**CONTRACT CHANGE ORDER**

CCO No. 5	Suppl. No.	Contract No. 78711	Road White Meadow Road and Peavine Ridge Road Storm Damage Repair	Federal Number(s) ELELC14
--------------	------------	-----------------------	--	------------------------------

PEAVINE RIDGE ROAD  
SLIDE REPAIR

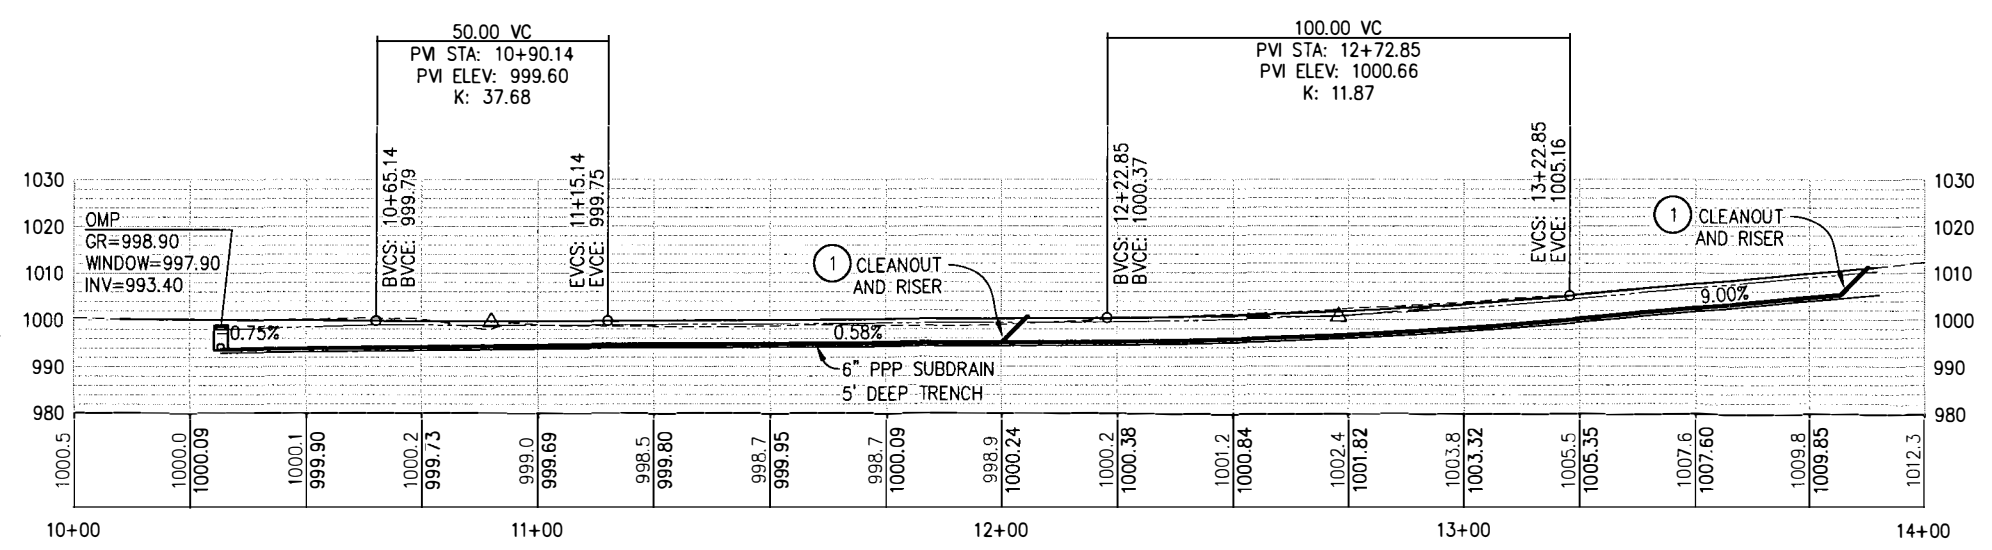
Remove heaved material. Will be left in suitable condition on site. (Evacuation to be agreed upon.)

Approx. location of new ETM

Clear up slopes & apply erosion control mats.

SHEET  
**EX-3**  
3 OF 3  
W.D. No. 78711

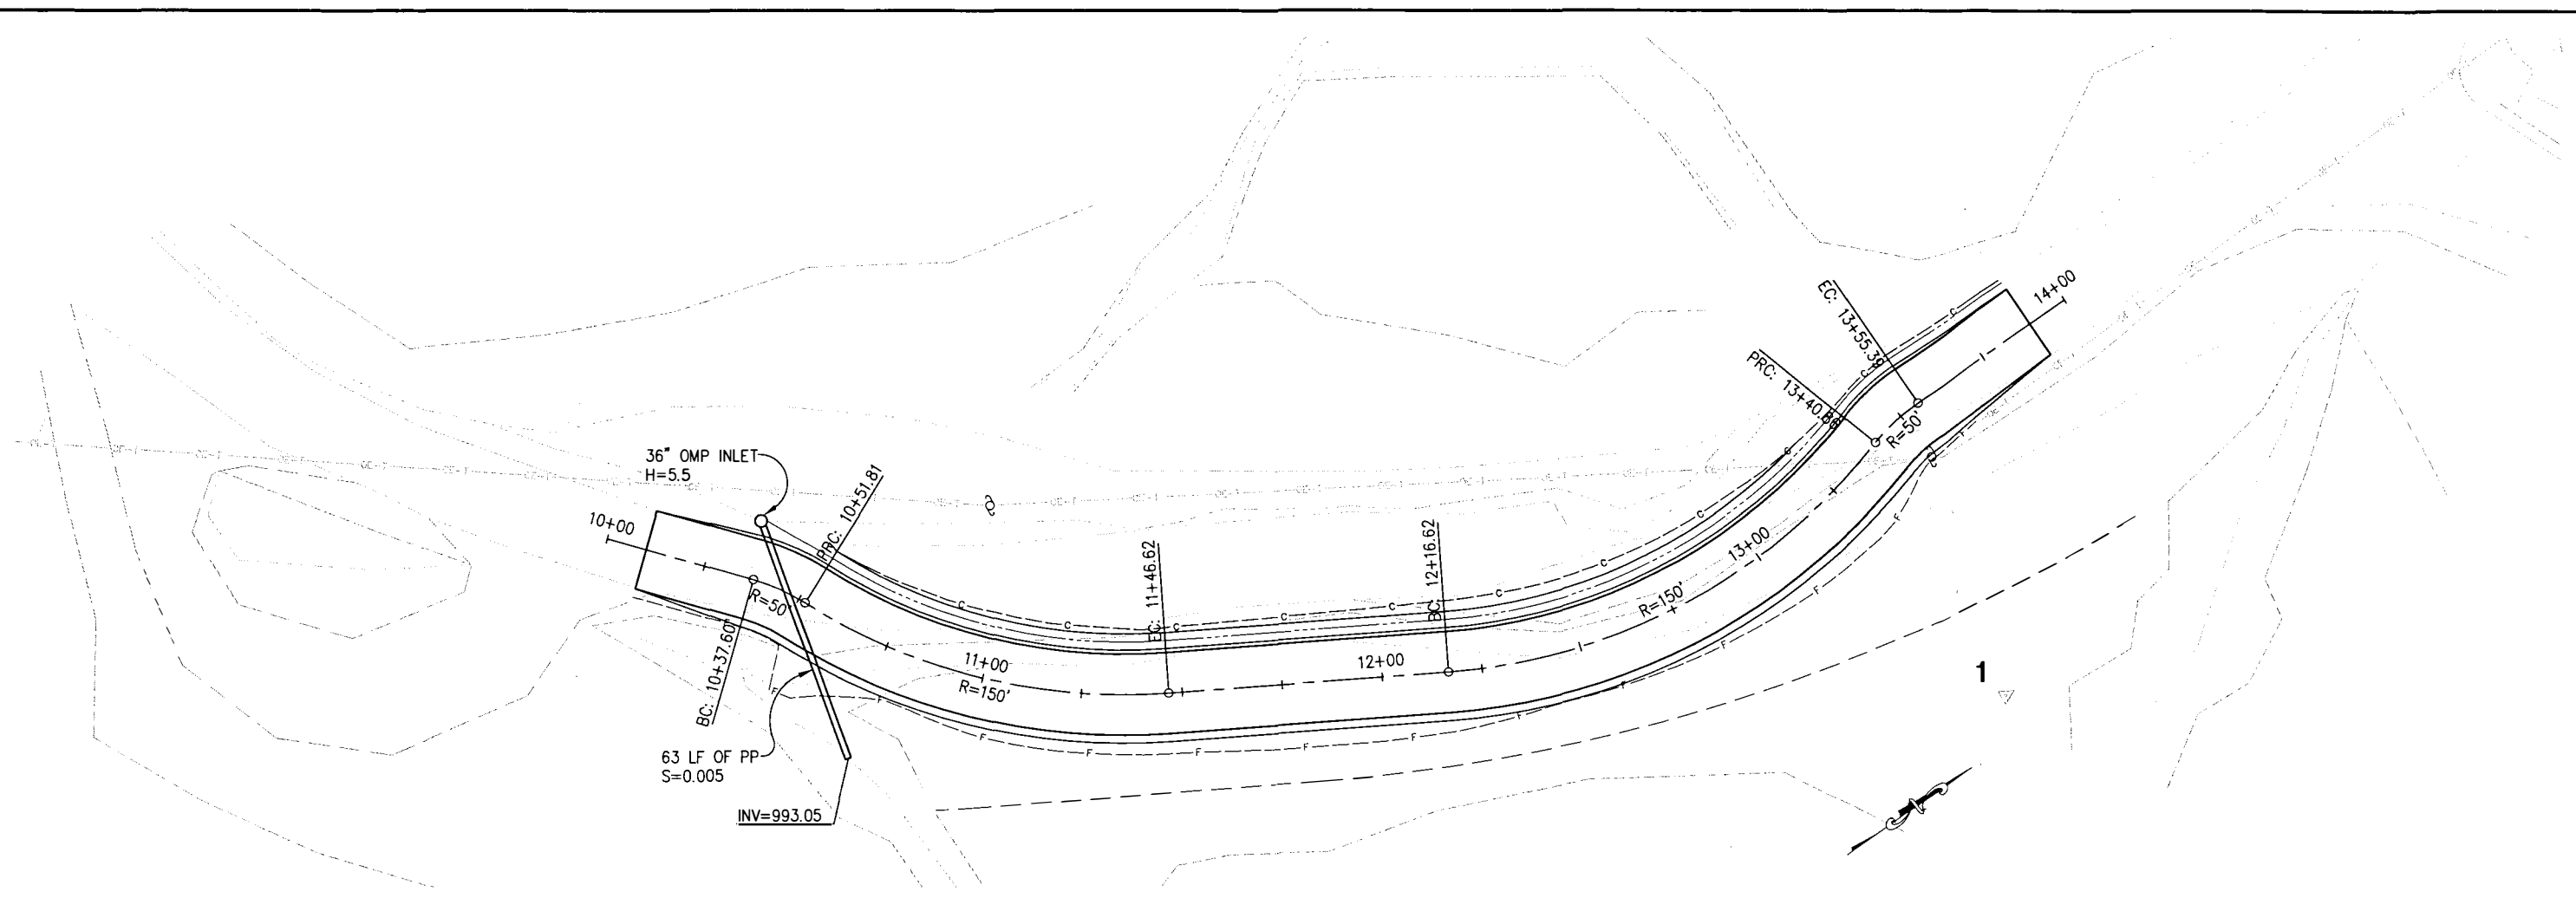
- CONSTRUCTION NOTES:**
- CUT=250 CY
  - FILL=105 CY
  - SECTION (3" HMA OVER 6" AB)
  - HMA=137 TONS
  - AB=140 CY
  - 360 LF 6" PPP SUBDRAIN (SMOOTH WALLED INTERIOR)
  - 1 EA OMP INLET
  - 63 LF 18" DRAIN PIPE
  - ① - CLEANOUTS, TOTAL OF (2), EXACT LOCATIONS TO BE DETERMINED BY THE ENGINEER
